Re: Universe View Subdivision
Traffic Impact Analysis, HT#C09D016
Report dated November 28, 2022
Engineer's Stamp 11/28/2022

The subject final Traffic Impact Analysis received on November 29, 2022, been accepted and approved by the Albuquerque Planning Development Transportation Section.

UNIVERSE VIEW STRIP CENTER UNIVERSE BLVD NW ALBUQUERQUE, NM 87114

SITE PLAN

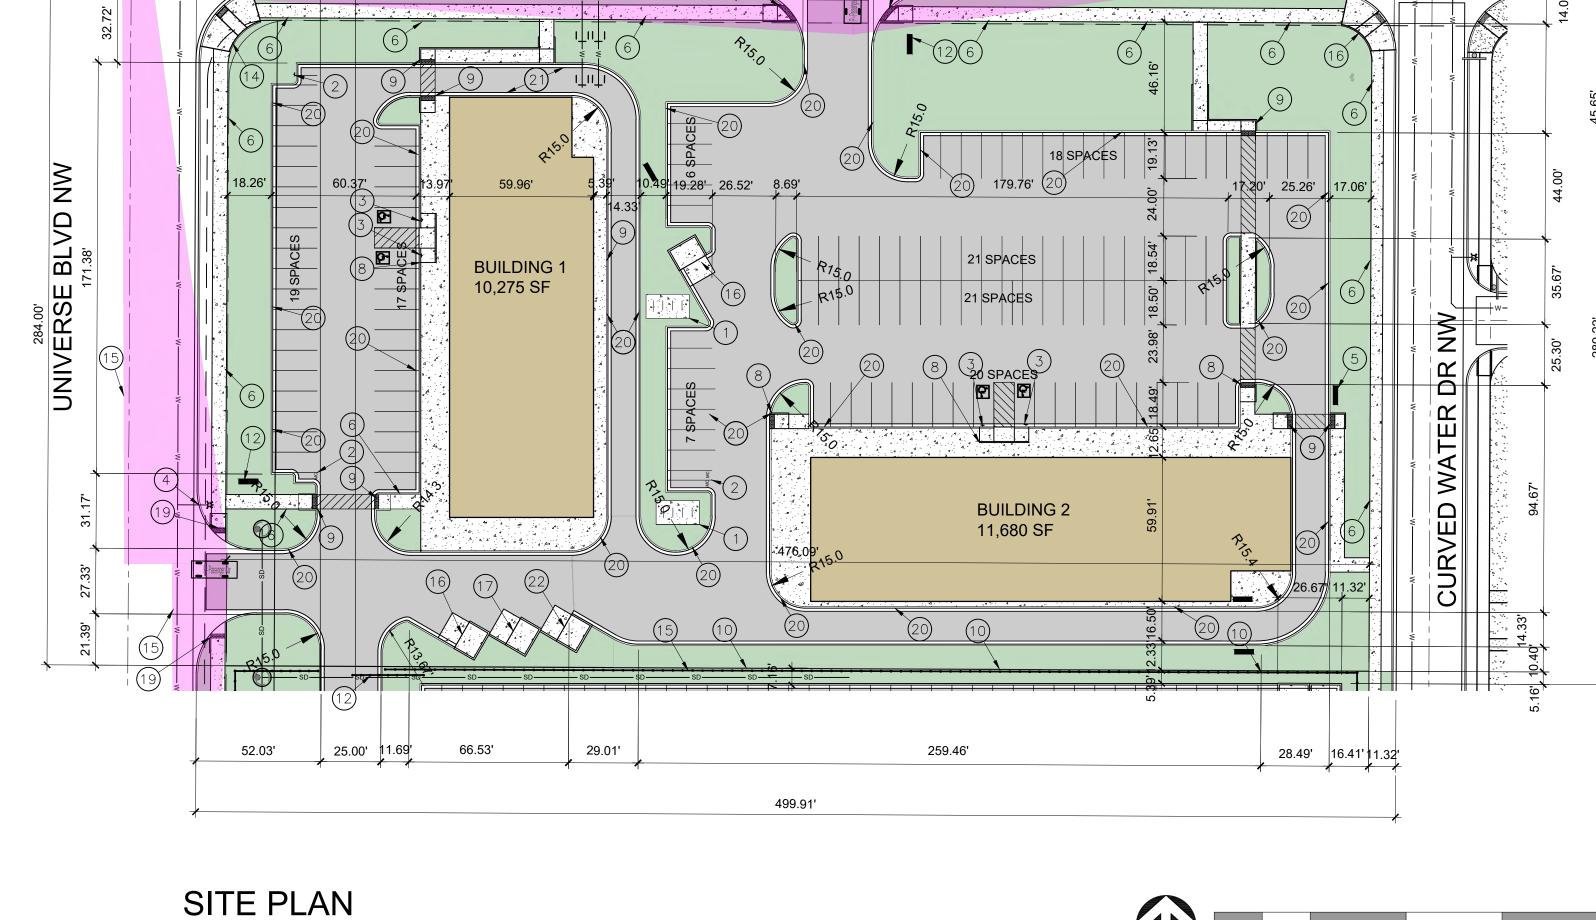
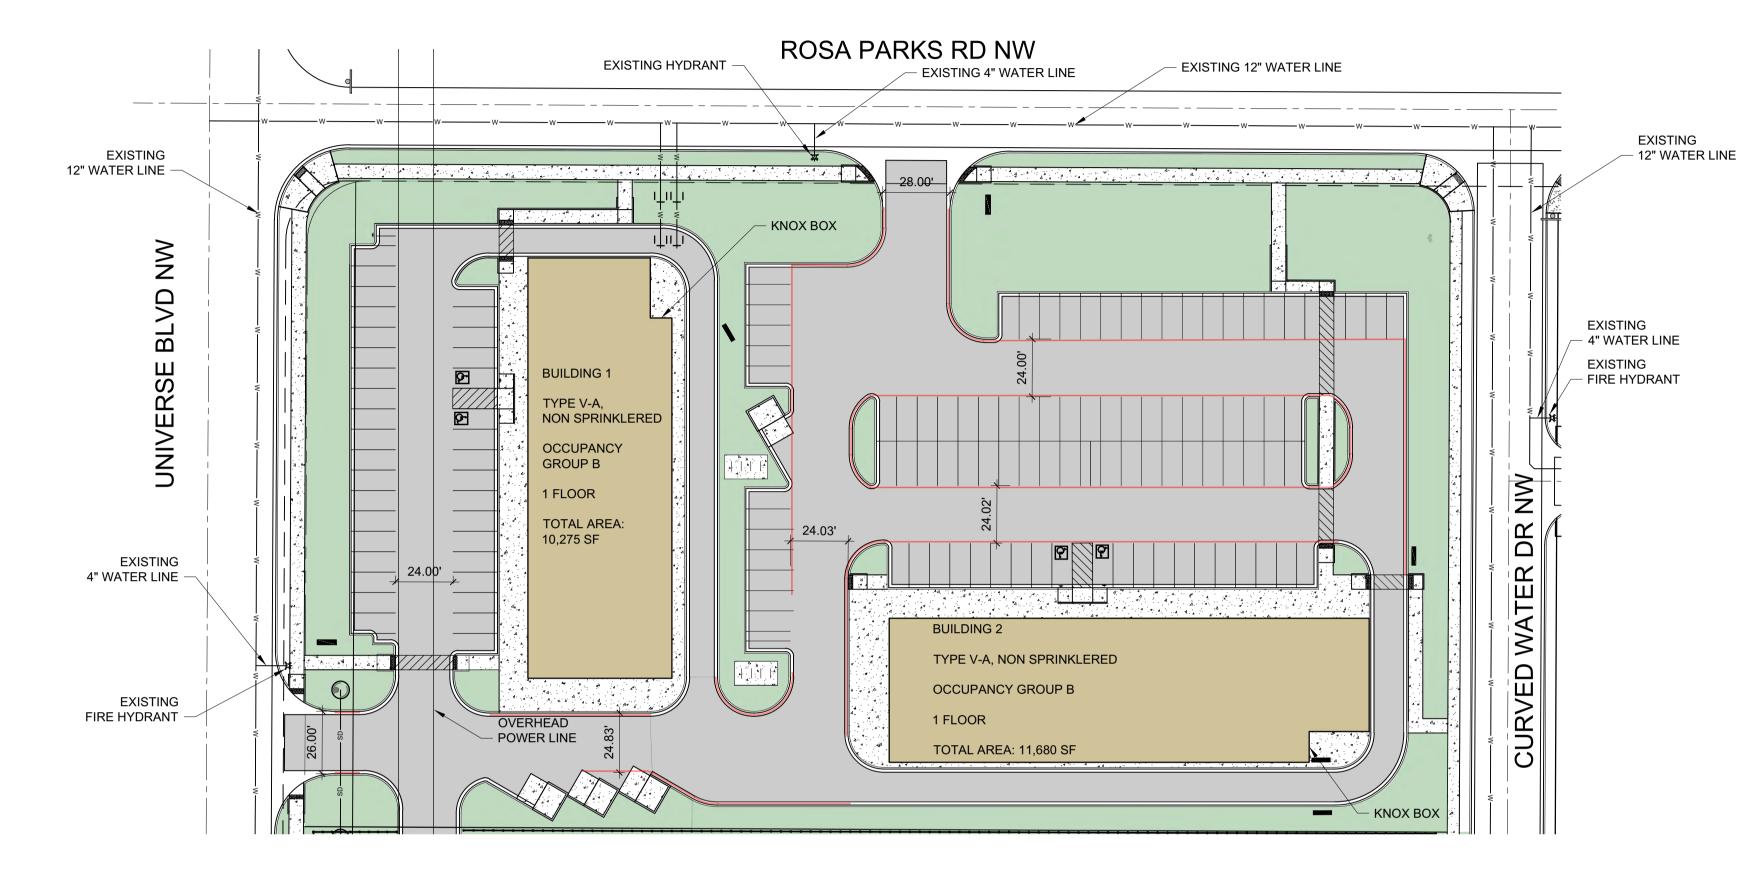
Approved for access by the Solid Waste Department for 2 trash enclosures\*\*which are required to have sanitary drains, and 1 recycle dumpster enclsoure. All containers are to be accessible between the hours of 5AM to 8PM.\*\* Herman Gallegos 07-07-23 Herman Gallegos
